# **802.3ck D1.4**

## **162.11.3 Cable Assembly Comments**

**Chris DiMinico**  
**MC Communications/PHY-SI LLC/Panduit**  
**[cdiminico@ieee.org](mailto:cdiminico@ieee.org)**

- **162.11.3 Cable assembly ERL**

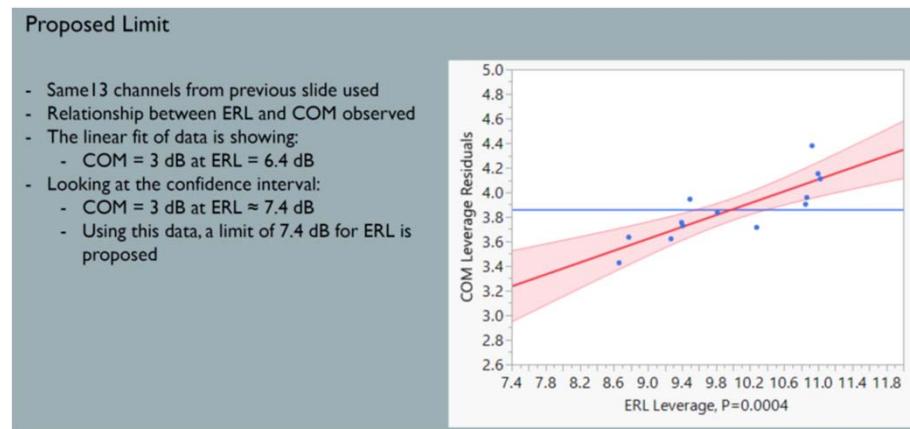
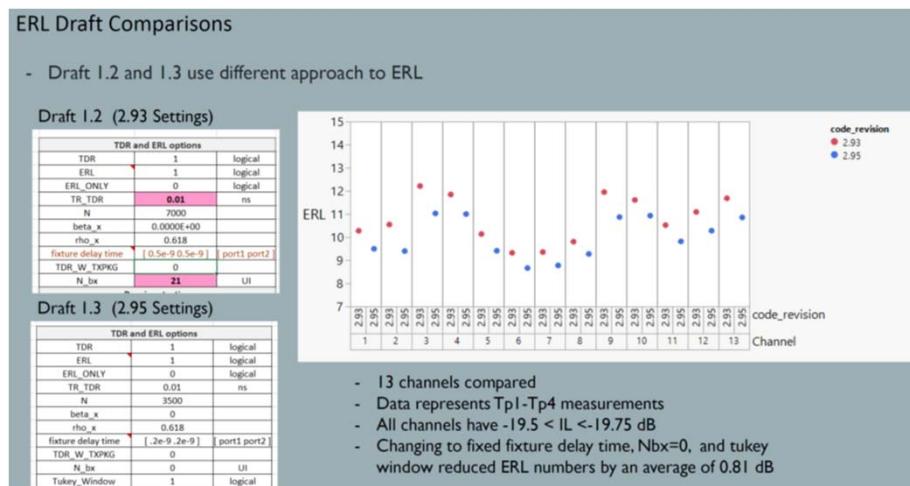
- **162.11.3 Cable Assembly Comments ERL**
  - **Comment #103 and #94 proposes 7.4 dB.**
  - **Comment#25 proposes a value or equation.**
  - **Comment#120 and #113 proposes 9 dB.**
  - **Update PICS with accepted value.**

- **162.11 Cable assembly characteristics – P163, L18, TBD = ?**

- **162.11.3 Cable Assembly Comments ERL**
  - Comment#120 and #113 proposes 9 dB
  - Adee: >>The host min ERL is 7.3 dB, a cable assembly is supposed to have significantly lower reflections than a host, and the measurement is through an MCB which should be better than a minimal host.
  - The alternative value 9 dB has a justification based on the MTF proposal in comment #131 (10.3 dB).
  - [https://www.ieee802.org/3/ck/public/20\\_10/champion\\_3ck\\_02\\_1020.pdf](https://www.ieee802.org/3/ck/public/20_10/champion_3ck_02_1020.pdf) page 5 shows all but 2 channels meet this specification.
